Access Compliance Report

Public Rights-of-Way

Intersection ID: 43015	Main Street: BRISTOL_PLACE_CT	Cross Street: SPRINGS_FARM_LN	Location: NE
ADA ID: 555186A33E2B	Ramp Type: PerpDiag	Initial Pass/Fail: Pass	Overall Compliance: No
		Severity Score: 17.5

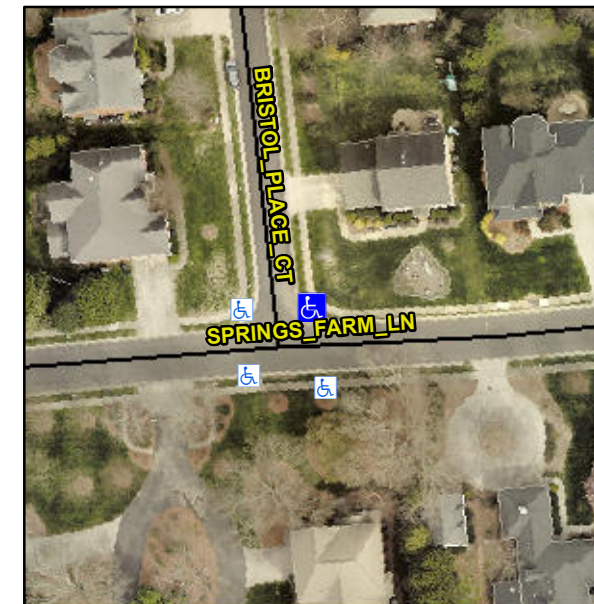
R304.2.2-Perp, R304.3.2-Para, R305, R302.7.2

Compliance	Description	Data	Compliance	Description	Data
N/A	Ramp Length (in)	49.0	Yes	Ramp Slope (%)	5.3
Yes	Ramp Width (in)	48.0	Yes	Ramp XSlope (%)	0.1
N/A	Flare Type LT	Sloped	N/A	Flare Type RT	N/A
N/A	Flare Slope LT (%)	8.2	Yes	Flare Slope RT (%)	8.3
N/A	Flare Traversable LT?	Yes	N/A	Flare Traversable RT?	Yes
Yes	Landing Length (in)	49.0	No	DWS Provided?	No
Yes	Landing Width (in)	48.0	N/A	DWS Contrast?	No
No	Landing Slope (%)	2.9	N/A	DWS Length (in)	N/A
Yes	Landing X Slope (%)	1.8	N/A	DWS Full Width?	No
N/A	Landing Curb? (Y/N)	No	N/A	DWS Offset (in)	N/A
N/A	Shared Landing?	No			
Yes	Gutter Ponding?	No	Yes	Gutter Slope (%)	1.6
No	Gutter Lip Ht (in)	0.5	Yes	Gutter X Slope (%)	0.1
N/A	Painted X Walk1?	No	N/A	Painted X Walk2?	No
	X Walk 1 Direction	To W		X Walk 2 Direction	To S
N/A	X Walk 1 Width (in)	N/A	N/A	X Walk 2 Width (in)	N/A
	X Walk 1 Slope (%)	1.0		X Walk 2 Slope (%)	4.4
	X Walk 1 X Slope (%)	1.6		X Walk 2 X Slope (%)	1.2

Remove & Replace Curb Ramp With Two New Directional Ramps or Equivalent. Grind Gutter Lip.
